Planning Commission Department of Planning, Housing, and Zoning

AGENDA Thursday, July 11, 2024 1:30 p.m.

TO: Kent County Planning Commission SUBJECT: #23-34 – Morgnec Road Solar, LLC

Preliminary Site Plan Review – Utility-Scale Solar Energy System

MORGNEC SOLAR- PROPOSED BUFFER PLANTING RENDERING (2 YEAR GROWTH)

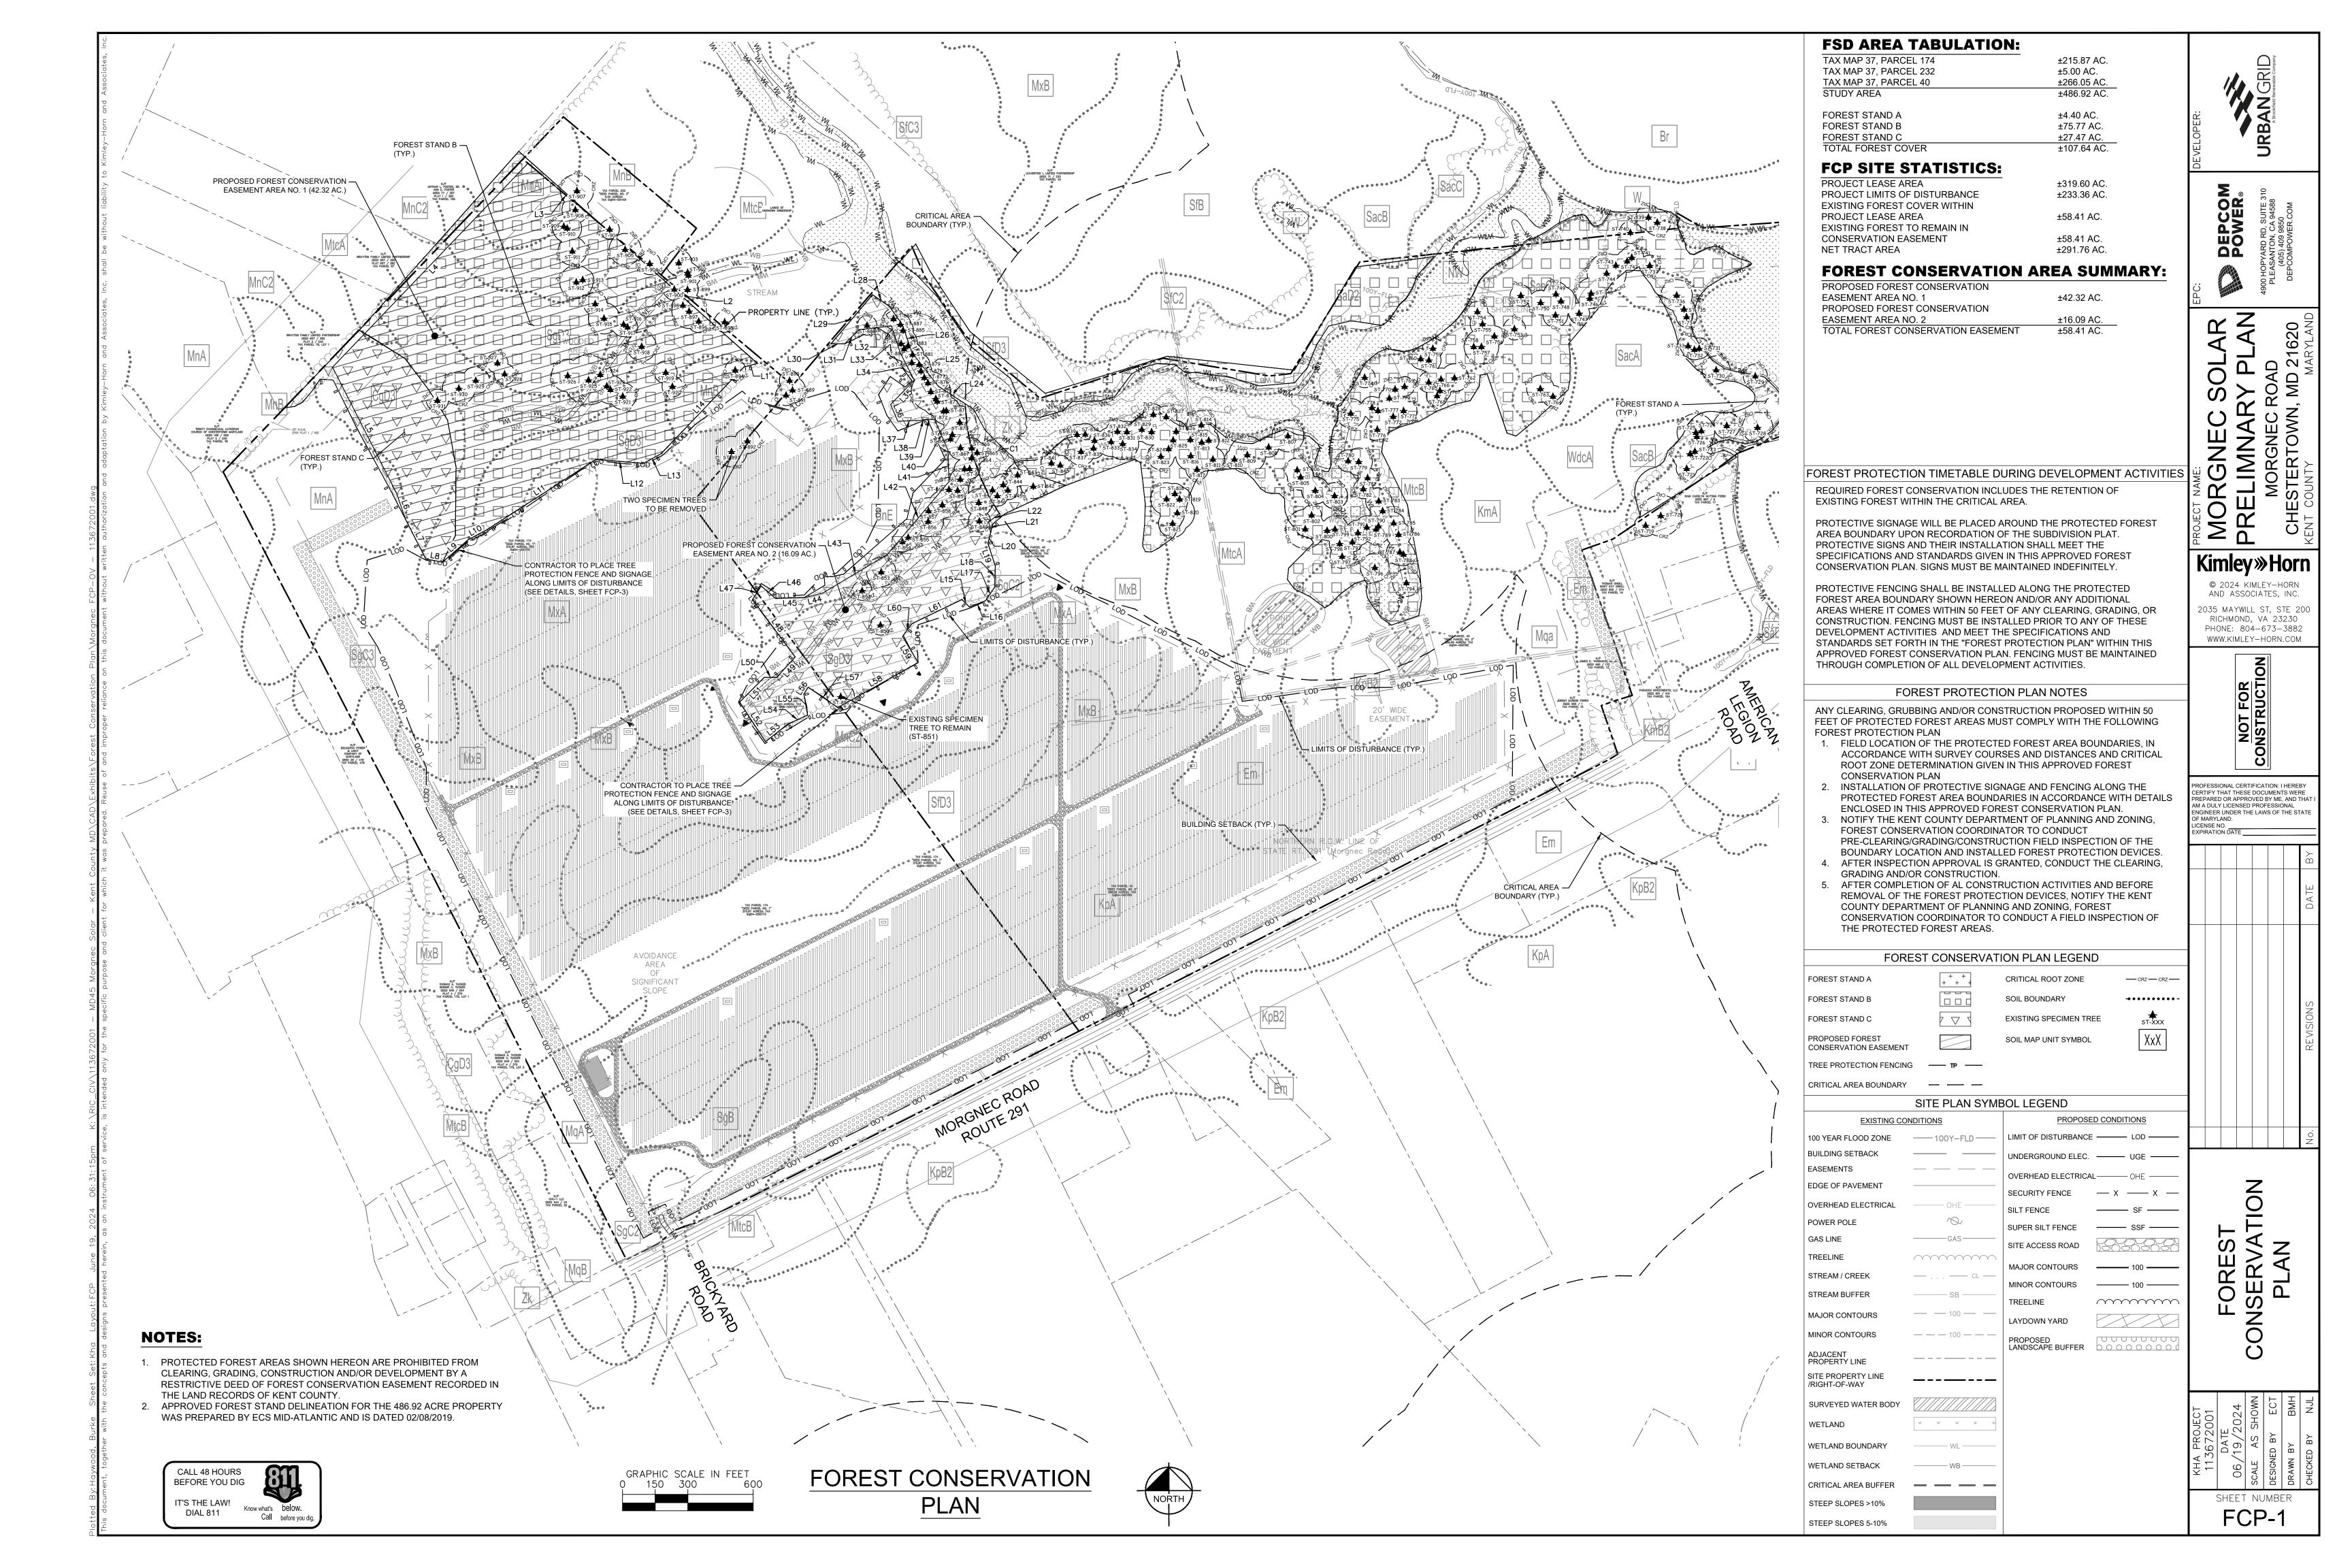
- Existing forest that predominates the northern and eastern portions of the development site may satisfy the buffer standards. The exception to this is the unforested segment of the project site where Parcels 174 and 488 meet. A 60-foot-wide buffer will need to be added along this segment.

- The submitted landscaping plan (Sheet CP-610) illustrates four planting zones: a hedgerow composed of mixed trees and shrubs to serve as a wind break, a low pollinator meadow around the solar array of grasses no more than 30 inches high to be mowed once annually, a pollinator habitat under the solar array to function as wildlife habitat to be mowed once annually, and a densely vegetated buffer composed of mixed trees and shrubs.

- Details of proposed species, placements, and tree caliper and heights at time of planting have not been provided. The applicant has indicated that the final buffer detail with spacing and species list is being developed and will be provided with the final plan.

- It is not clear whether a waiver of the 3-foot berm requirement will be requested.
- An irrigation plan has not been submitted.

- Response: See Site Plan Sheets CP-210 through CP-215 for locations of proposed buffer plantings. If additional screening is required, the existing vegetation will be supplemented with additional plantings.
